U.S. ARMY CORPS OF ENGINEERS
JACKSONVILLE DISTRICT

**116680 LIDO KEY HURRICANE
AND STORM DAMAGE REDUCTION PROJECT
(Preconstruction, Engineering and Design Phase)
SARASOTA COUNTY, FL**

VALUE ENGINEERING REPORT

31 October 2013

VE P2A - MODIFY GROIN XS'S.

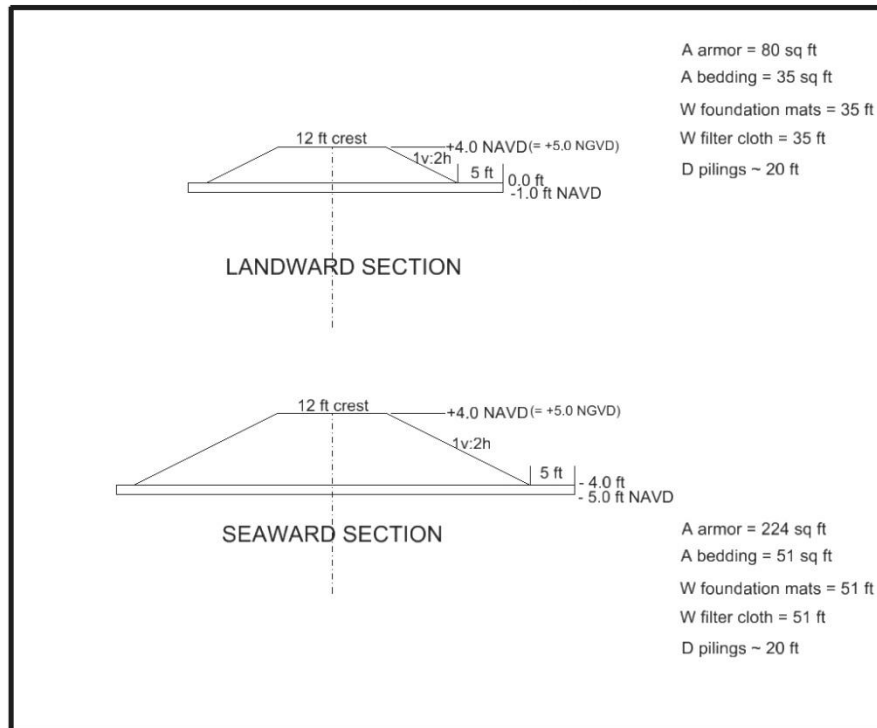
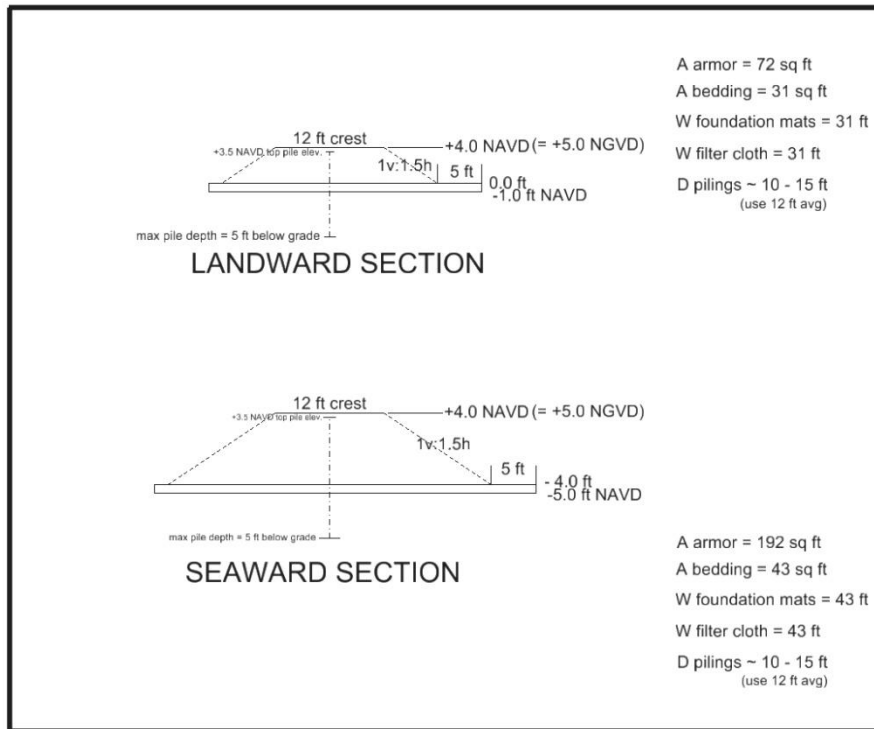
PROPOSAL NO. P2A, (Ideas 2.11, 8.18, 8.14, 8.62, 8.63): *Groin Optimization (Optimize dimensions, use local stone in marine mattresses, reduce sheet pile lengths).*

The groin cross-section design as described in the 2004 Feasibility Study consists of the following: all three structures would be constructed of 2-ton, 165 pcf granite, with a crest elevation of +5 ft NGVD (= +4.0 ft NAVD), a crest width of 12 feet, and side slopes of 1v : 2h. Two layers of granite (total 6 ft thick) would be placed over a layer of 400-lb core stone. Core and armor stone are placed over a layer of unconstrained bedding stone. A vinyl sheet pile wall would be driven down the centerline of each groin to -24 feet to sand-tighten the structures.

Several VE proposals are included in this design since these improvements represent current construction practice and/or changing site conditions since the 2004 study. The use of foundation mattresses (**VE # 8.18**) is recommended in accordance with current design practices and as a cost-saving measure. Furthermore, the foundation mattresses can be filled with either native Florida limerock or imported granite, whichever is cheaper (**VE # 2.11**), with no loss of performance. Side slopes will be steepened to 1v : 1.5h along both sides of each groin (**VE # 8.13**) in order to reduce the quantity of materials (and cost) required. The original 1v : 2h side slope will be maintained at the head of each structure, to avoid compromising structural stability. A variable base elevation (**VE # 8.14**) was incorporated into all VE alternatives as described in the general overview document, based on the latest survey data. The top elevation of the sheet pile was reduced (**VE # 8.62**) to +3.5 ft NAVD, which equates to 6 inches below the crest of the groins. This modification was recommended for safety reasons, as all structures are expected to accommodate heavy pedestrian traffic. The depth of embedment of the sheet piles was reduced (**VE # 8.63**) from -24 feet to 5 feet below existing grade, because the piles are included only to provide a sand-tight barrier, not as structural members. Armor stone placement will provide the required lateral stability of the sheet pile wall. Other VE proposals recommended further reducing groin cross-sectional dimensions (**VE # 8.09, 8.12**), but this was not possible because the groin crest widths and elevations as described above are currently at the minimum dimensions required to still be in accordance with current design guidance.

Marginally increased sediment bypassing could occur during storm events due to the slight lowering of the sheet pile elevation. This rate is expected to be minimal, and would only occur during period of heavy overwash. However, some bypassing is desirable in order to renourish the downdrift beaches. Decrease in depth of penetration of sheet piles can result in loss of stability of the pile wall during construction; stone should be placed along the newly-constructed wall to increase lateral stability. A shallower base elevation could result in an increased potential for scouring along the downdrift (south) side of the structures. To avoid scouring damage a 5-ft wide scour apron would be constructed by extending the foundation mattresses beyond the southward-facing toe of the structures as shown.

VE P2B - Remove Sheet Pile, Narrow Crest, Chink.

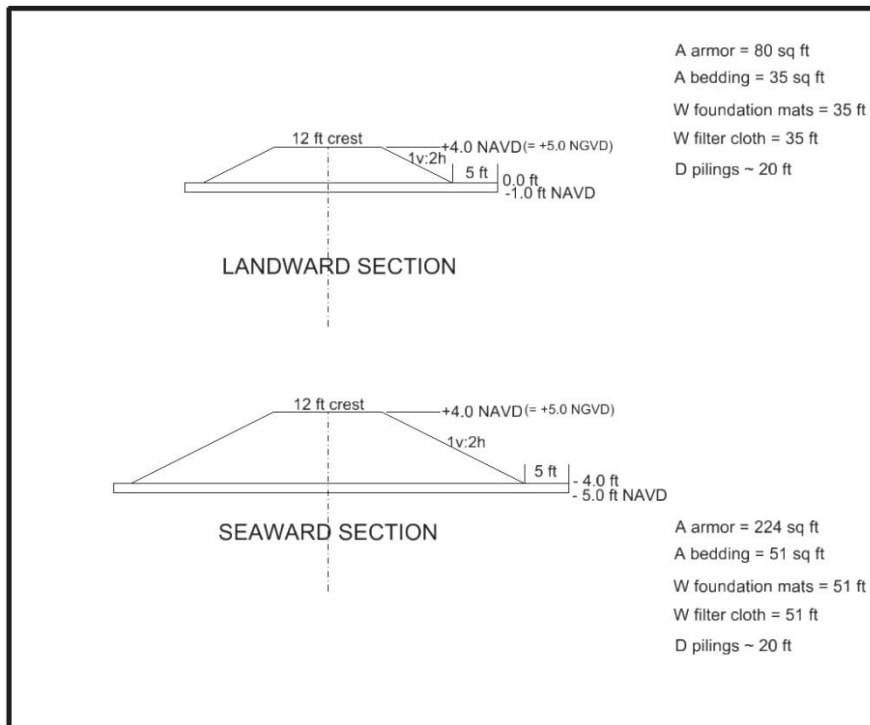
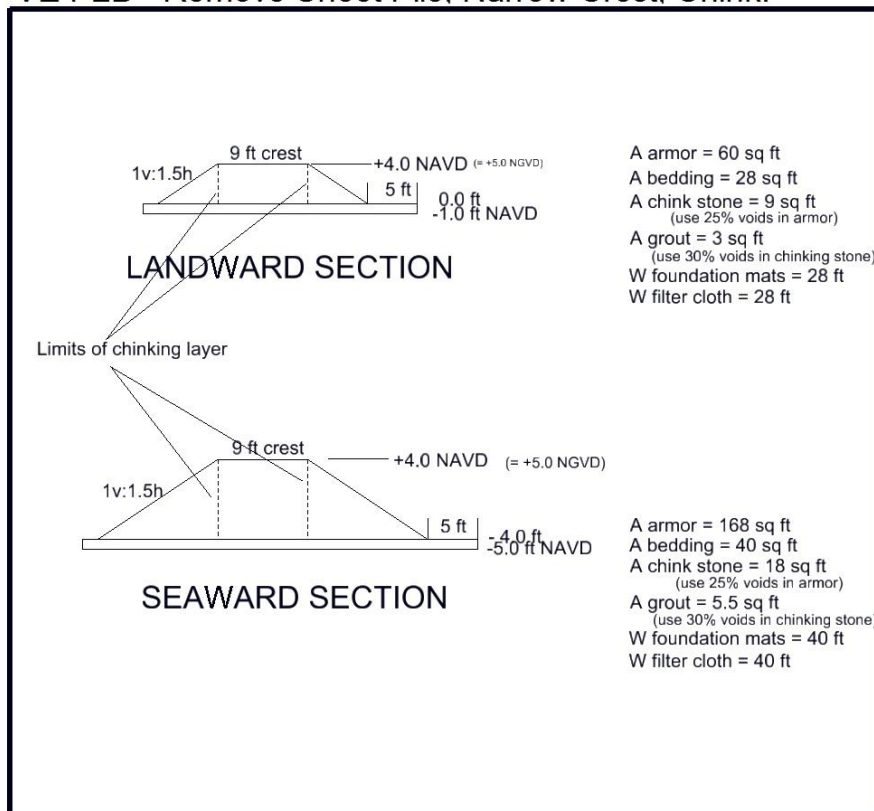
PROPOSAL NO. P2B (Ideas 2.11, 8.18, 8.14): *Groin Optimization (Optimize dimensions, use local stone in marine mattresses, replace sheet pile with grouted chinking stone).*

This proposal further refines the design presented in Alternative P2A, substituting the use of chinking stone instead of sheet pile to provide the required sand-tightening. The sheet pile wall would be removed from all three structures and replaced with chinking stone, which would be placed within the voids of the armor stone during construction. Chinking stone would be grouted as it was placed, to further reduce voids and increase stability of the chinking layer. Chinking stone density would be 165 pcf, to further decrease the potential for any ungrouted stone to be washed out of structure by wave action. Corps guidance requires a minimum of 3 stone-widths across the crest of such rubble-mound structures. The original groin design was 4 stones wide (12 ft), to allow for the placement of 2 stones on each side of the sheet pile wall. Without this sheet pile wall the crest can be reduced to 3 stones wide (9 ft), which will reduce the volume of stone accordingly.

The use of the more expensive granite (vs locally-produced limerock) is recommended for the chinking stone, due to its greater density and resistance to breaking. The use of this more expensive stone could negate some cost savings. Grout would be added to the chinking stone as it is placed, both to further decrease the permeability of the structure and to bind the chinking stone together so that wave action does not displace the chinking stone outward through voids in the armor stone. This option also increases the cost somewhat, and includes the risk that grout may leak into adjacent waters during construction. Heavily-grouted sections may crack and break over time due to differential settlement, possibly compromising the long term sand-tightness of the structure.

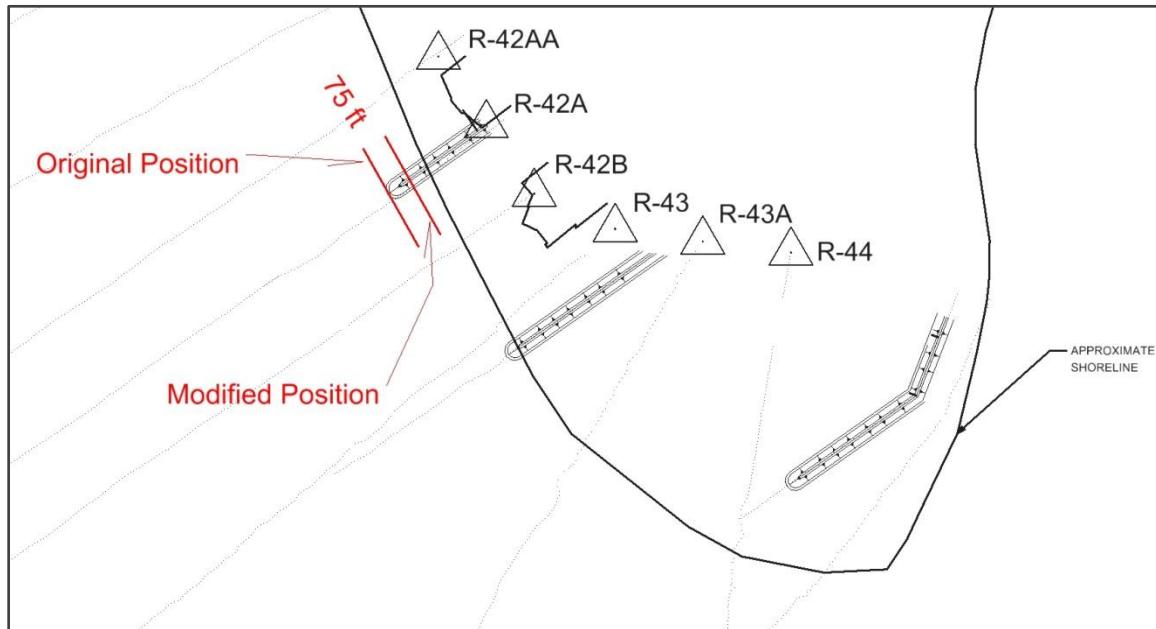
VE proposal 8.49 suggest a re-examination of the lengths of the groins, to determine if any of the structures could be shortened without compromising project performance. A re-analysis of the plan-view layout of the groin system is not the intention of this proposal; Proposal #8.49 is more of a response to changing site conditions since the numerical modeling was performed for the 2004 Feasibility Study. At the time of the shoreline modeling analysis for the 2004 Feasibility Study, aerial photography shows that the offshore positions of the seaward tips of the northern 2 groins were about equal, with each situated about 275 feet seaward of the shoreline position at that time. Since that time the shoreline has been renourished and its position has changed considerably, and the future performance of the groin field could be impacted as a result. Based on current shoreline aerial photography, the position of the seaward tip of the northern groin would be approximately 175 feet from the (2013) waterline, while the position of the seaward tip of the central groin is only about 100 feet from the waterline. By extending the northern (updrift) structure further offshore, this arrangement has the potential to impound large volumes of sediment updrift of the groin field. While beneficial to the shoreline to the north of the groin system, the shoreline within the field could be starved of material until the northern groin becomes fully impounded. Based on the present shoreline position it appears that the northernmost groin could be shortened by up to about 75 feet with no significant loss of performance of the groin field system. This would position the seaward end of the northern groin approximately 100 feet seaward of the waterline, which is the same relative position as the second groin. Shortening this structure could improve performance of the groin field by allowing additional material to bypass the northernmost structure, allowing more material to enter the two shoreline cells contained within the groin field. This layout would provide more effective nourishment of the shoreline along the south end of Lido Key. Essentially, this VE proposal recommends all of the design modifications as described in VE Proposal # P2A, with the only additional change being that the seaward end of the northern groin be shortened by 75 feet.

The width of the accreted beach berm north of the northern groin would be reduced accordingly, but would still be well in excess of the 80-foot design template. Increased sediment bypassing would occur, especially during storm events as material bypasses around the seaward tip of the structure due to wave action. However, adequate bypassing is essential to maintaining the downdrift beaches.

VE P2D - Same as P2B, N. Groin 75 ft Shorter.

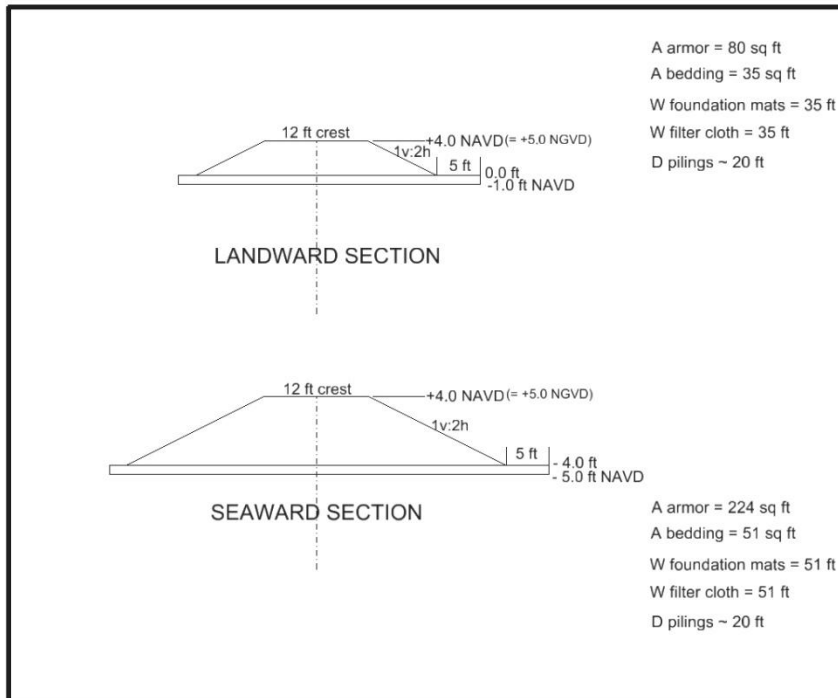
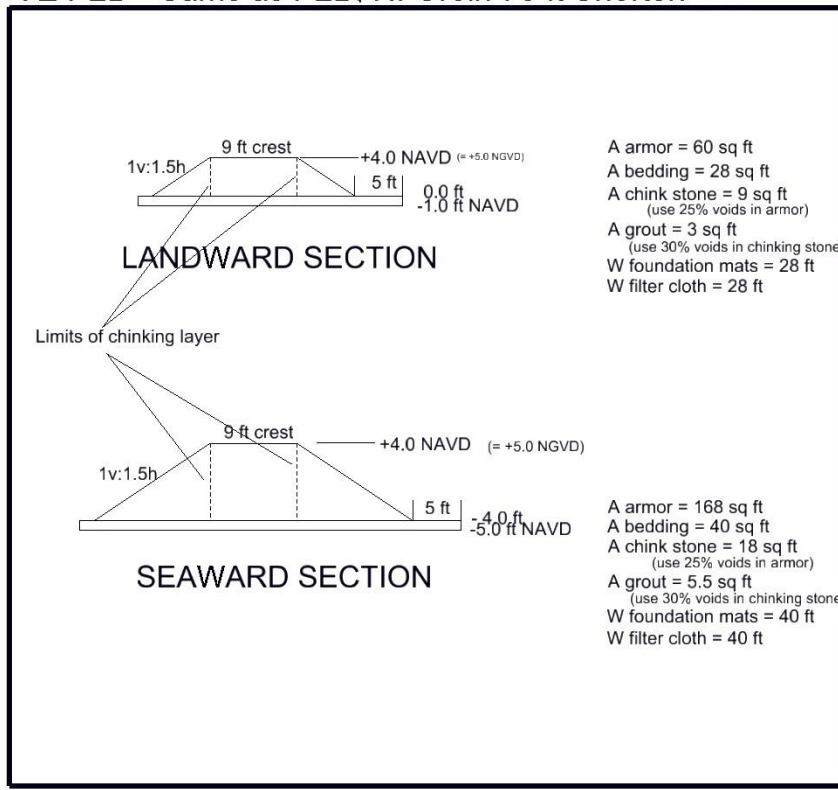
PROPOSAL NO. P2D (Ideas 2.11, 8.18, 8.14, 8.49): *Groin Optimization (Optimize dimensions, use local stone in marine mattresses, replace sheet pile with grouted chinking stone, selectively shorten groins).*

This alternative further refines the design presented for proposal P2B. Specifically, the length of the northernmost groin would be reduced by 75 feet, in accordance with the changing site conditions described in the discussion for Proposal P2C above. All other aspects of the cross-section and plan-view layout would be the same as for Proposal P2B : chinking stone would still be the means of sand-tightening the three structures; the only difference is that the length of the northern groin would be reduced by 75 feet at its seaward end.

Shortening the length of the northern structure by 75 feet would result in a narrowing of the berm width north of the structure by a similar amount, but the resulting berm would still be adequate to provide the desired level of protection.
